Addendum 01

Project: CSV Lansdowne Auditorium Renovation **Date:** 06 December 2024
330 Lansdowne Ave, **Pages incl. cover:** 21
Toronto ON

The following changes, additions, deletions and clarifications are hereby made an integral part of the documents, including the drawings and specifications for the above project.

TITLE
RIGGING & DRAPERY RCP

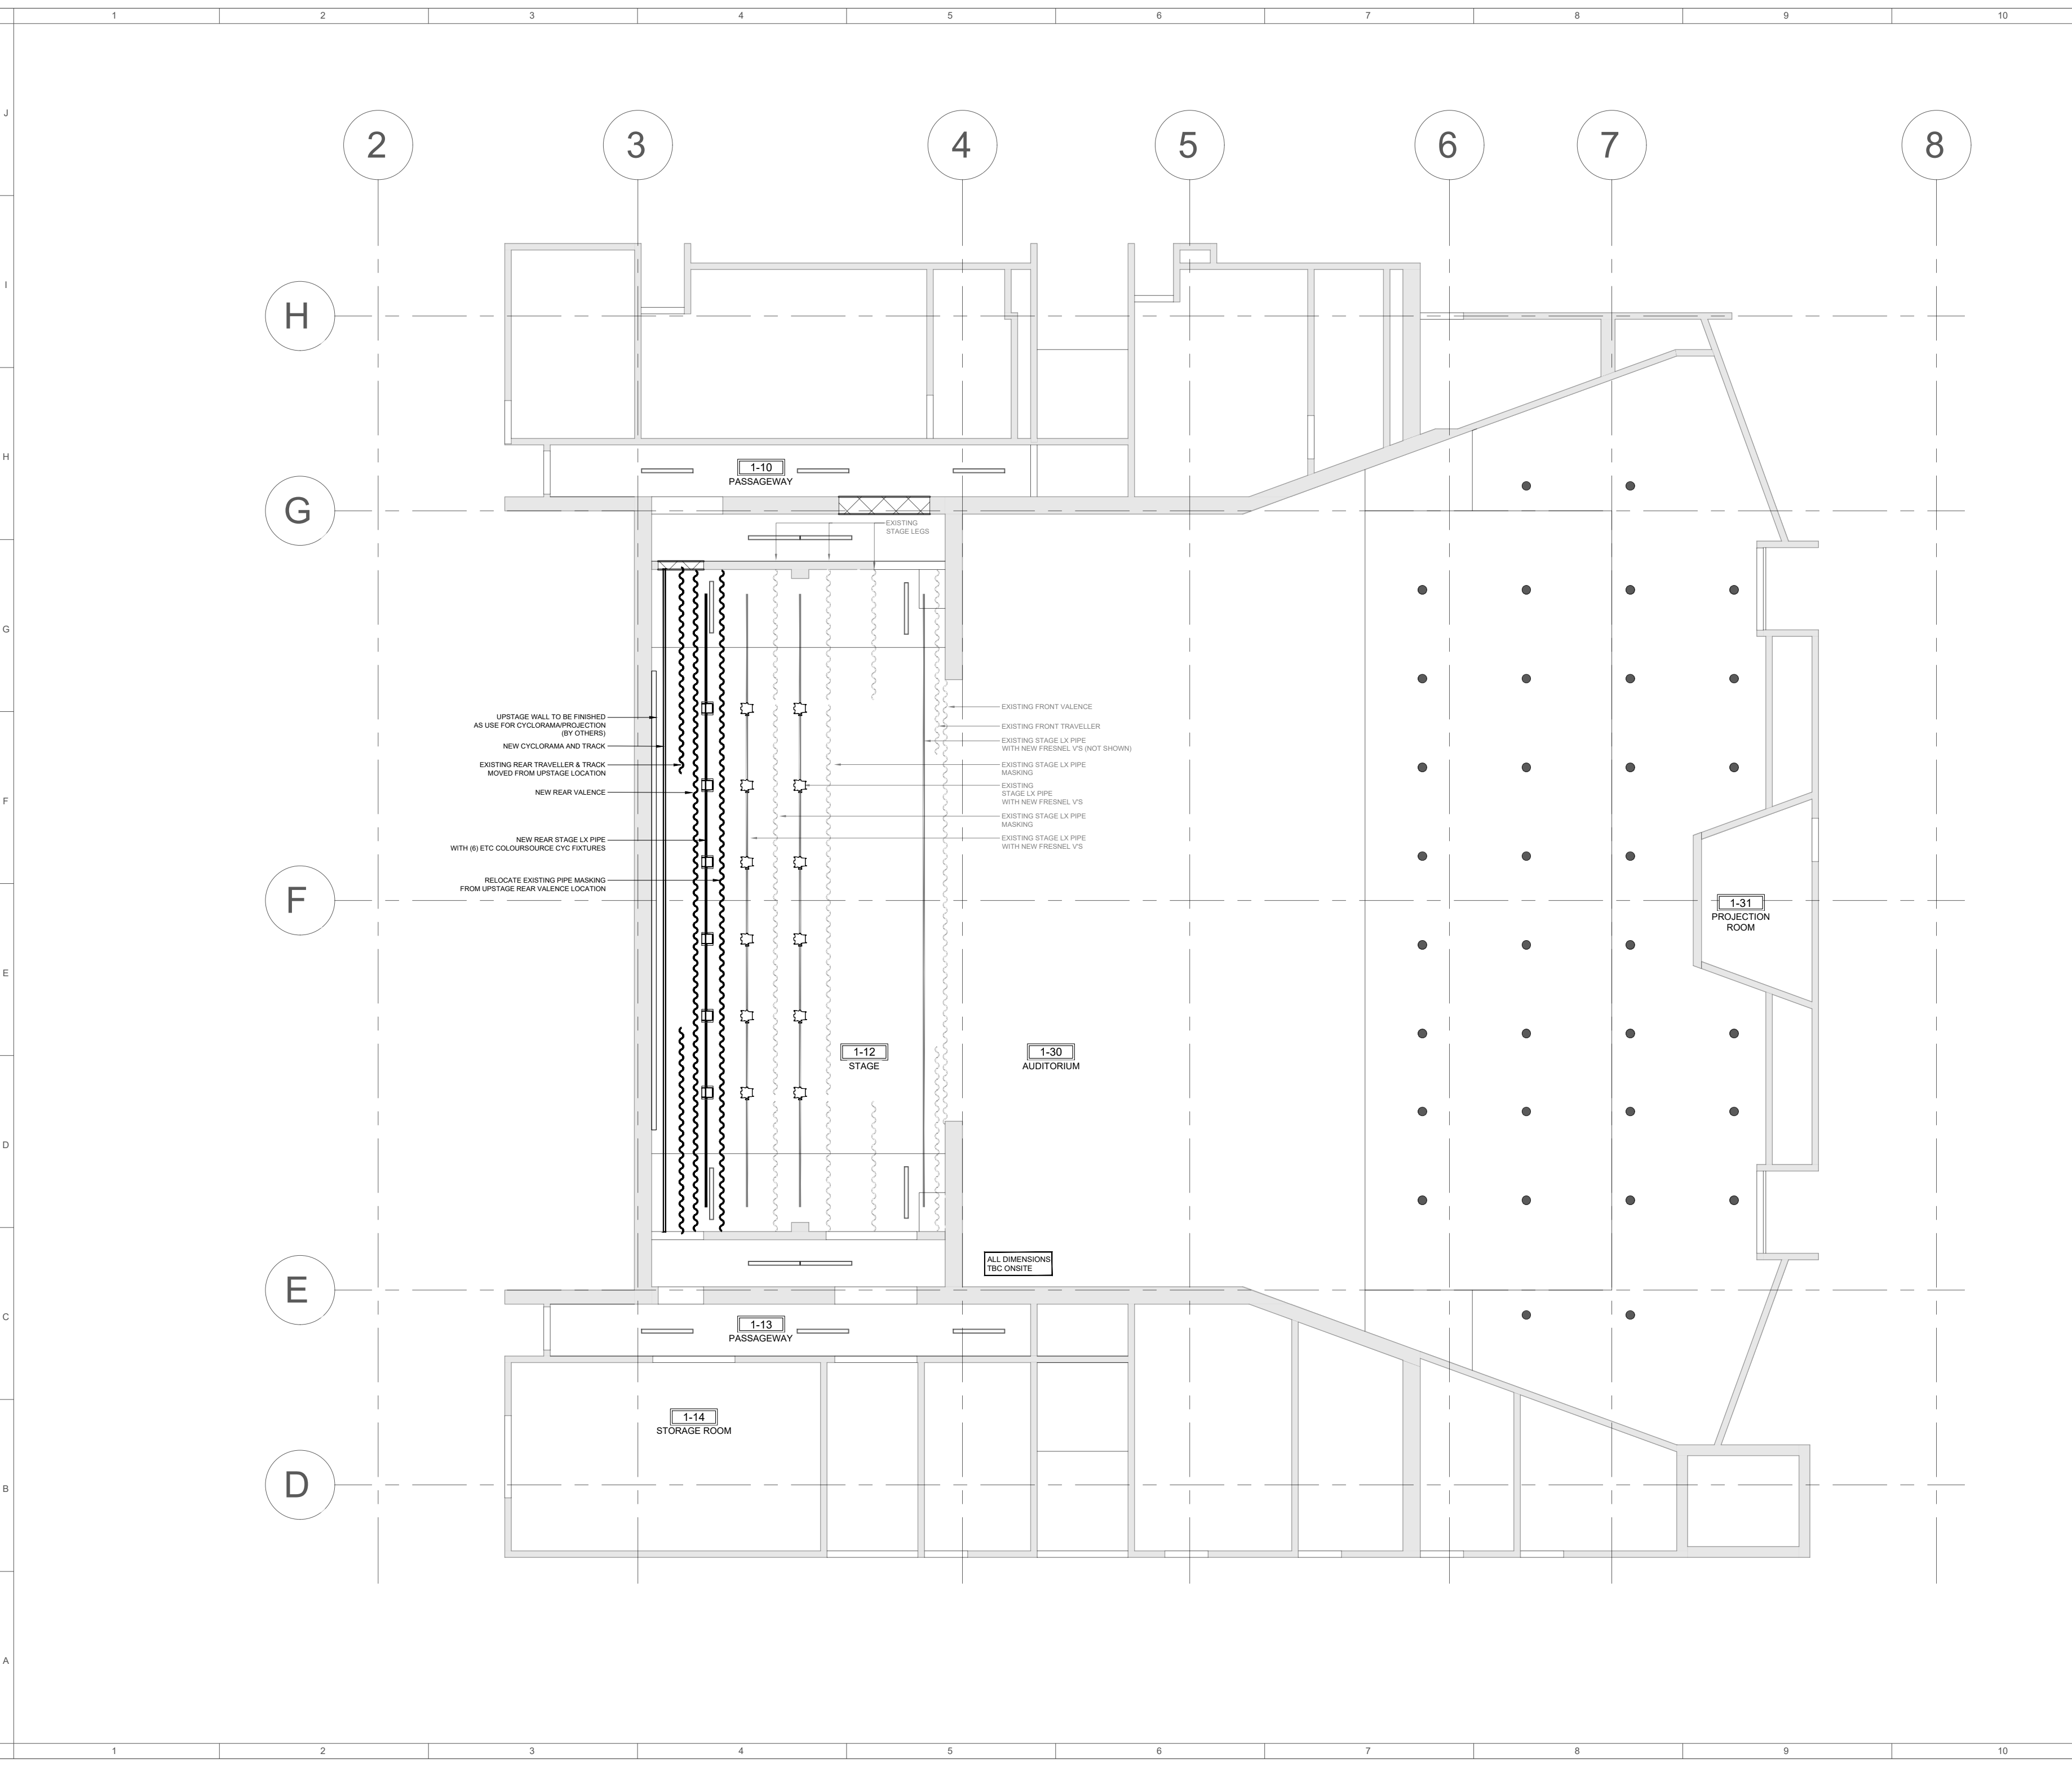
1.19	Question: NO NEW Rigging or Drapery details in the spec BUT are indicated as S&I on the division of responsibilities... I see plenty of existing drapery and rigging on AV-Drawings... is all staying, no new? Answer: All existing rigging and drapery are staying, there is new being added, see AV-1002 & AV-2002 and Appendix AV-A Bid Sheet/Equipment List.

1.20	Question: Appendix "AV-A" Equipment List is missing from Spec please provide. Answer: Refer to updated Appendix AV-A Bid Sheet/Equipment List.
1.21	Question: D11 63 20 Theatre Arts Production Lighting ***No Lighting plot or fixture details on the drawings. Please provide Answer: Refer to updated drawings AV-1002, AV-1003 which include rough guideline as to fixture placement. Final placement to be approved through installer shop drawings.
